Subject: AP1000 COL Response to Request for Additional Information (SRP 3.7.1)

AP1000 TECHNICAL REPORT REVIEW

RAI Response Number: RAI-SRP3.7.1-SEB1-01
Revision: 0

Figure RAI-SRP 3.7.1-SEB1-01-1 - Horizontal (X-Direction) Comparison of HRHF Spectra

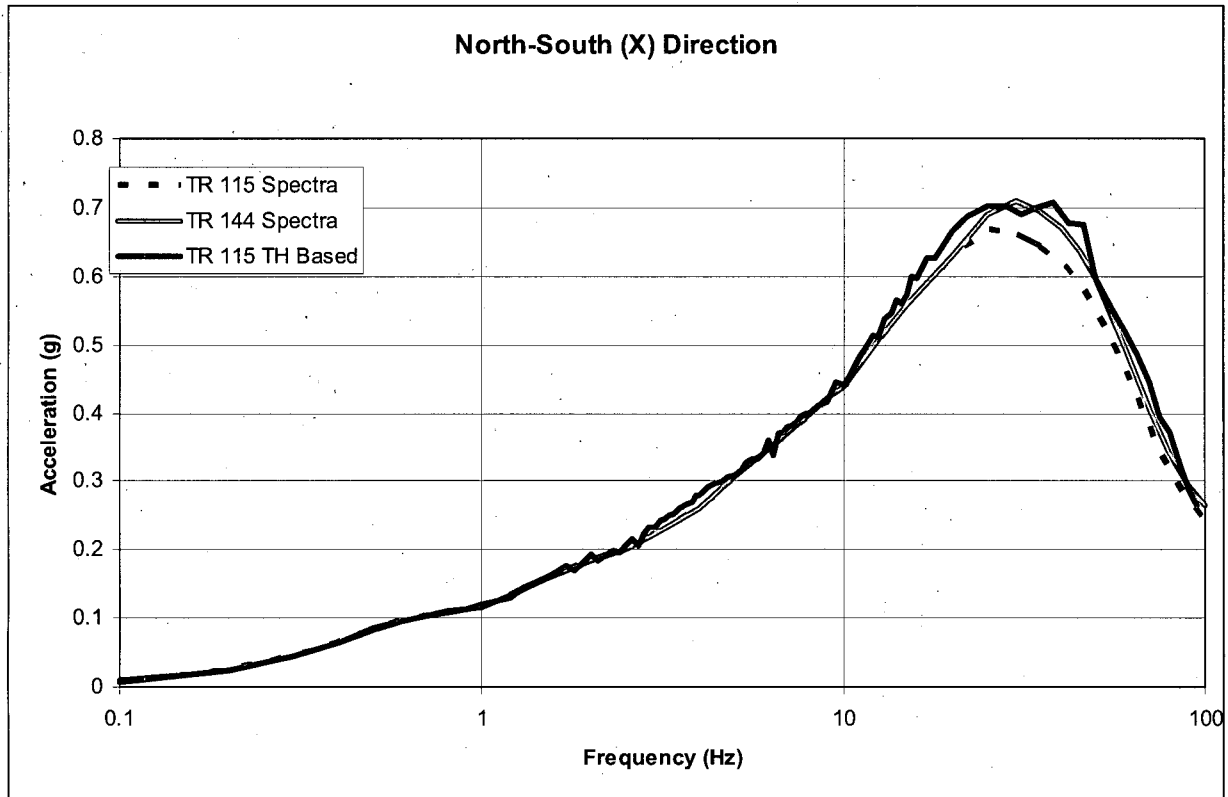
The applicant has not demonstrated that "The HRHF GMRS included in these figures is bounded by the response spectra time-history used for the evaluations in APP-GW-GLR-115." Without presenting any details, the applicant simply indicates that the response spectra of the time history used for the AP1000 high frequency design analyses bound the new design response spectra presented in TR-144, and consequently, all results and conclusions presented in TR-115 remain valid for the new high-frequency design spectra. To assist the staff in evaluating the applicant's conclusion, the staff requests the applicant to submit a graphical comparison at 5% damping of (1) the response spectra (2 horizontal and vertical) of the synthetic time histories, (2) the high-frequency design response spectra (horizontal and vertical) in TR-115, and (3) the high-frequency design response spectra (horizontal and vertical) in TR-144.

In Figures RAI-SRP 3.7.1-SEB1-01-1 through RAI-SRP 3.7.1-SEB1-01-3 are the comparisons requested. Note that the vertical spectra for TR 144 and TR 115 are the same, and therefore, TR 144 spectrum is over top of the TR 115 spectrum. The seismic response spectra labeled TR 115 Spectra are the smooth response spectra that were presented in Westinghouse Technical Report 115 (Reference 1). The seismic response spectra labeled TR144 Spectra are the smooth response spectra that was presented in Westinghouse Technical report 144 (Reference 2). The spectra labeled TR115 TH Based is the calculated seismic response spectra associated with the synthetic time histories that are used for the HRHF evaluation documented in Reference 1.
